PILGRIM WATCH'S SUPPLEMENTARY COMMENTS REGARDING GALL AMP XI.M41 BURIED AND UNDERGROUND PIPING & TANKS - NRC STAFF DRAFT REVISED AMP M41 (August 11, 2010 VERSION)-Docket: NRC-2010-0180 www.regulations.gov

XI.M41 BURIED AND UNDERGROUND PIPING AND TANKS

Figure 1 The Bathtub Curve

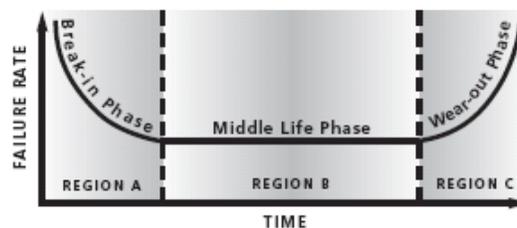
PW Comment 22: What evidence is there to justify a 10 year interval? This is the crux. One simply cannot squeeze all these situations into the same shoe box. 10 years is too infrequent period – especially in license renewal when components may well be entering the “wear-out” stage (Region C) of the Bath Tub Curve of degradation. Inspection frequencies need to be based on age.

Figure 1 The Bathtub Curve

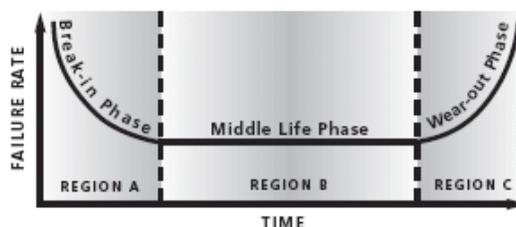
PW Comment 47: What evidence is there to justify a 10 year interval. This is the crux. One simply cannot squeeze all these situations into the same shoe box. 10 years is too infrequent period – especially in license renewal when components may well be entering the “wear-out” stage (Region C) of the Bath Tub Curve of degradation.
